before: round-3 record (r3_s12 run_26, FINAL_LAYOUT), kpex halo 8
S11 -10.16 dB S22 -10.28 dB MSB 8.36 dB LSB 2.38 dB BW 61.1 GHz swing 2.11 Vpp 167 mW 7268 um2

after: round-4 accepted (r4_s10 run_29, R4_LAYOUT), kpex halo 8
S11 -10.24 dB S22 -10.25 dB MSB 8.37 dB LSB 2.39 dB BW 61.5 GHz swing 2.21 Vpp 175 mW 7166 um2

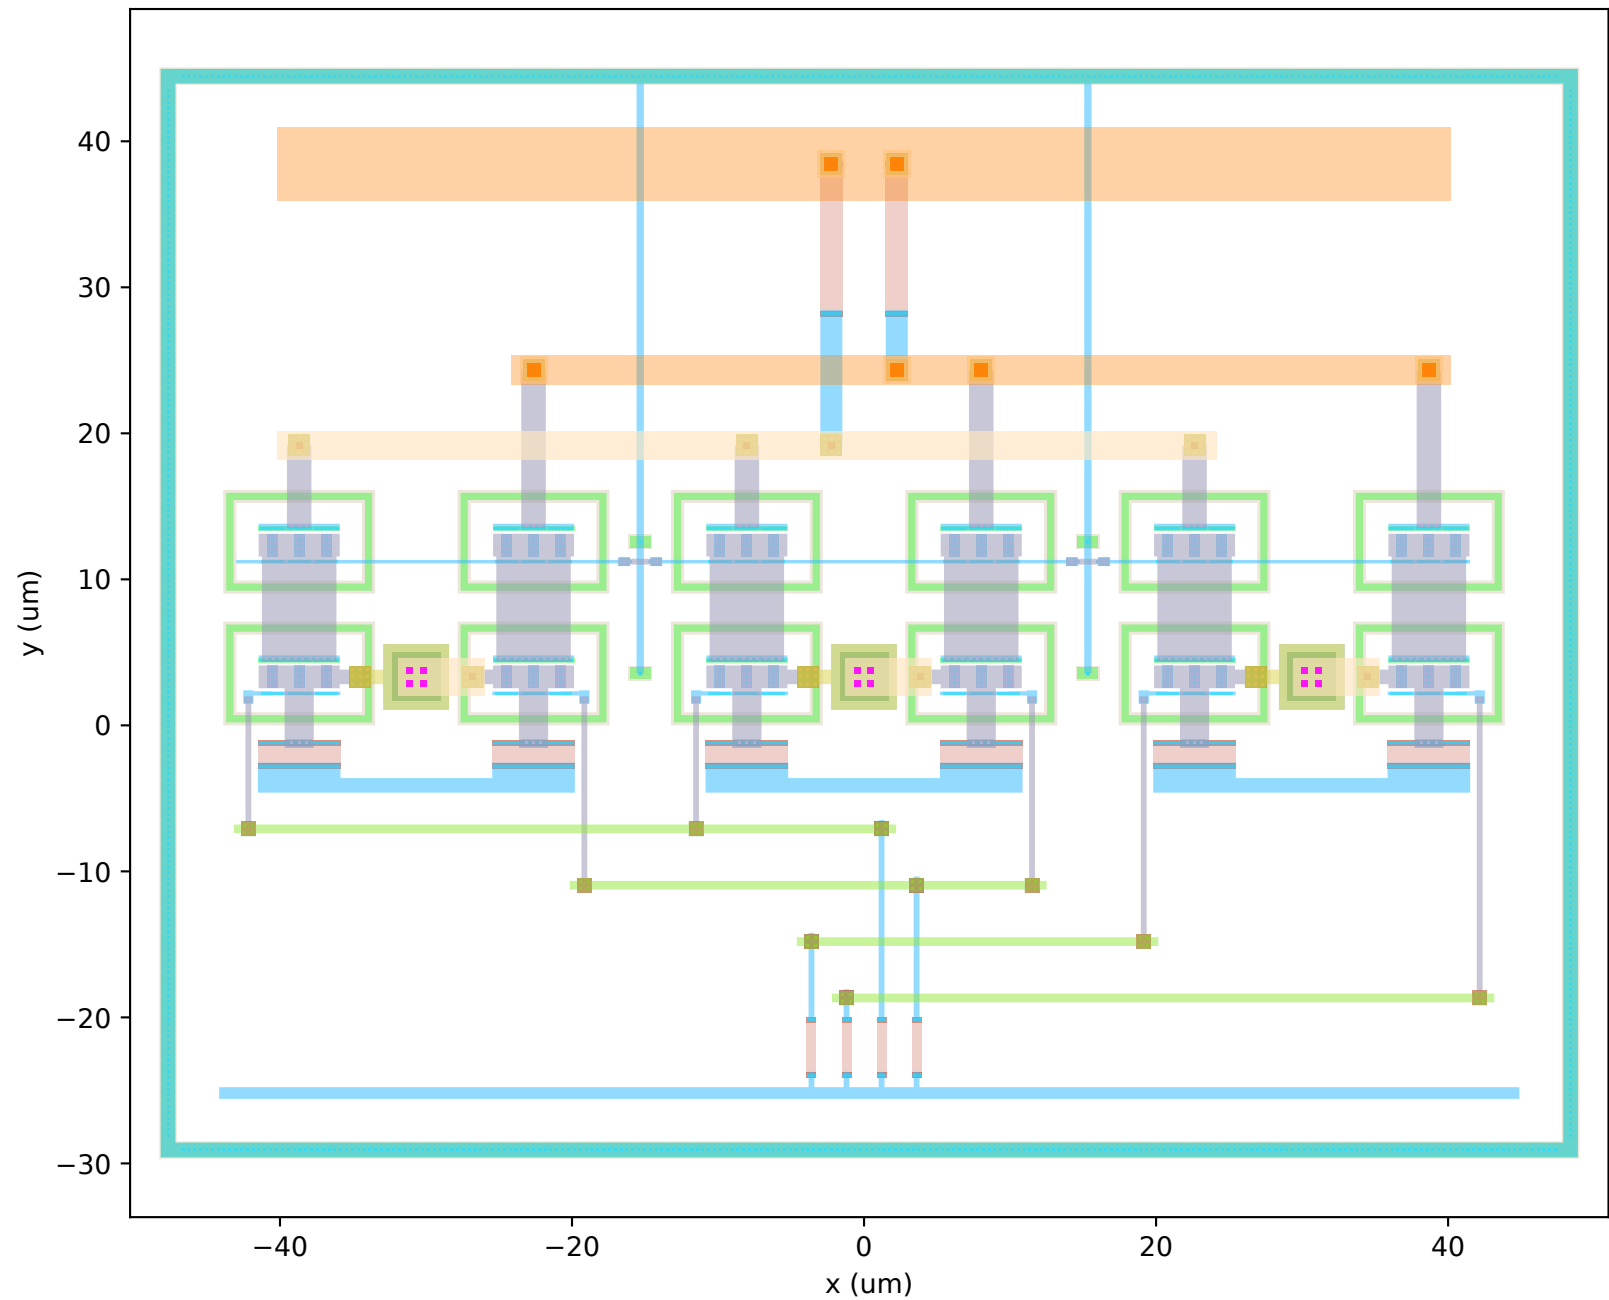
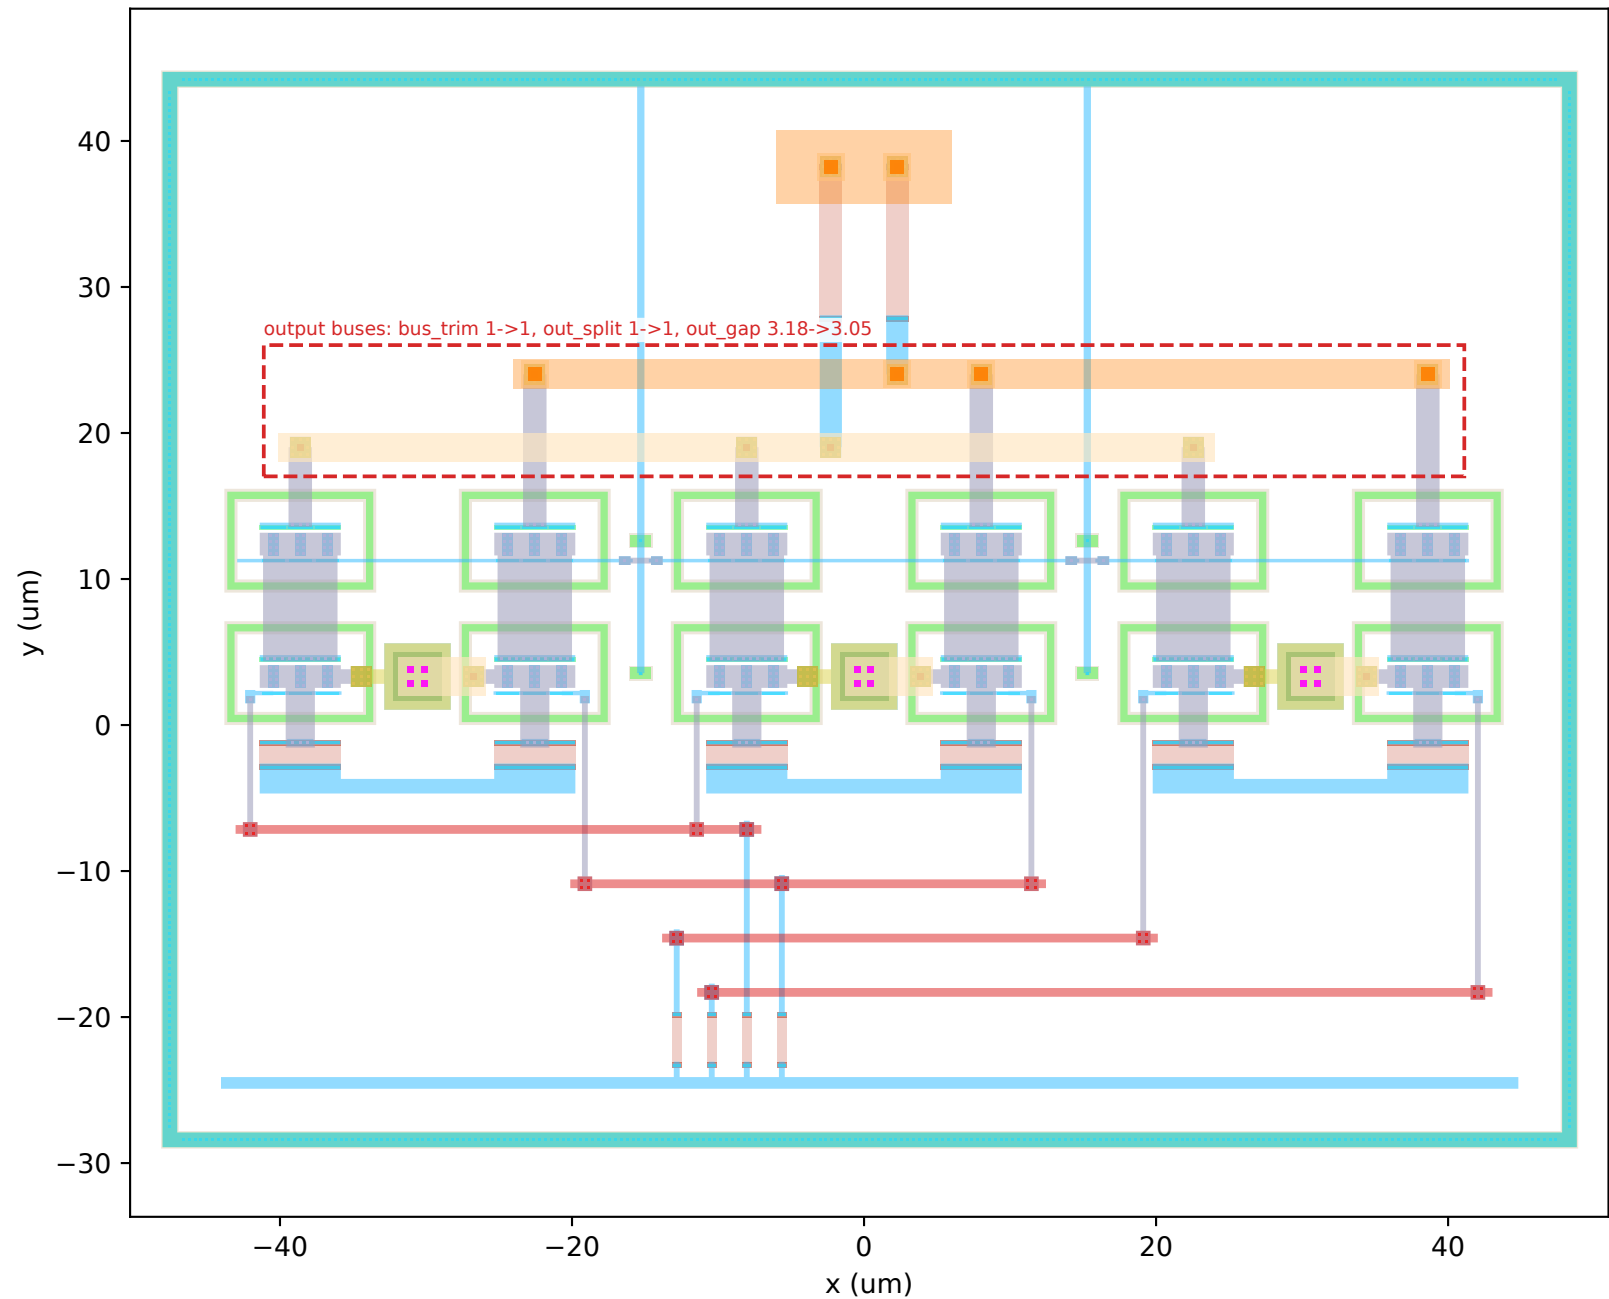
moved knobs: gap_x 5.65->5.66, row_gap 1.91->1.96, cell_gap 4.21->4.12, re_ohm 3.09->3.24, rc_ohm 51.77->52.08, rb_ohm 48.32->48.01, cdeg_ff 16.84->17.24, re_w 5.66->5.56, rc_w 1.51->1.52, rb_w 0.68->0.64, w_out 1.68->1.61, in_off 2.18->2.16, in_bus_gap 3.26->3.12, sub_off 1.33->1.3, out_off 2.06->1.88, out_w 1.97->1.94, out_gap 3.18->3.05, in_bus_lvl 0->3, rc_sep 4.48->4.55, rc_gap 2.87->2.82, vcc_trim 0->1, rb_off 0->-9.23, stack_w 1.47->1.43
